Barry to Dinas Powys - Active Travel Route

Consultation Report

Figure 1 - Proposed dropped kerb at Biglis roundabout

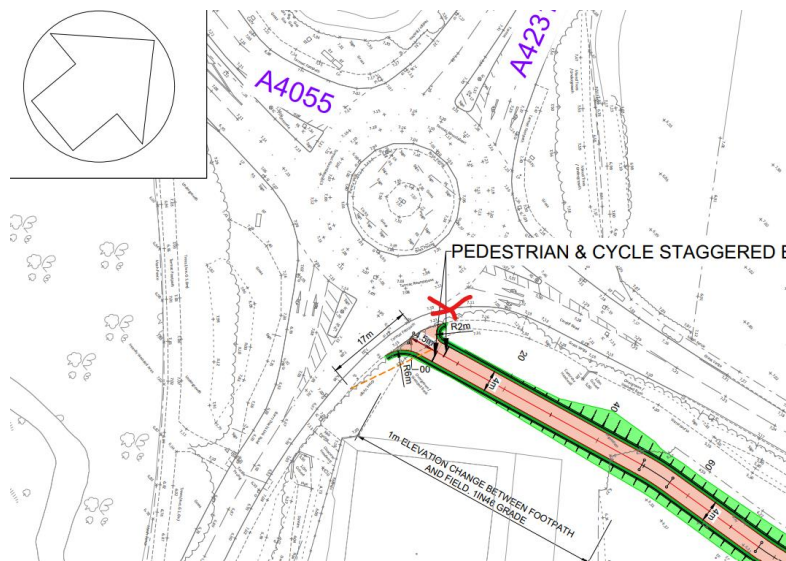
2. Provision for Cyclists Through Cadoxton: Currently, there is no provision for cyclists coming through Cadoxton. A dropped kerb where marked in Figure1 would allow cyclists to maintain flow travelling east from the A4055, round the roundabout, and provide easy access to the start of the track. This also applies to cyclists heading south down the A4231. The access point for many cycle lanes in Barry and the Vale involves an almost 180-degree turn, which slows cyclists down and increases the risk of being hit from behind and breaches Welsh Government Active

Travel design guidance. The guidance emphasises the importance of smooth and direct routes for cyclists to enhance safety and convenience. Smooth and direct junctions are particularly important for non standard cycles.
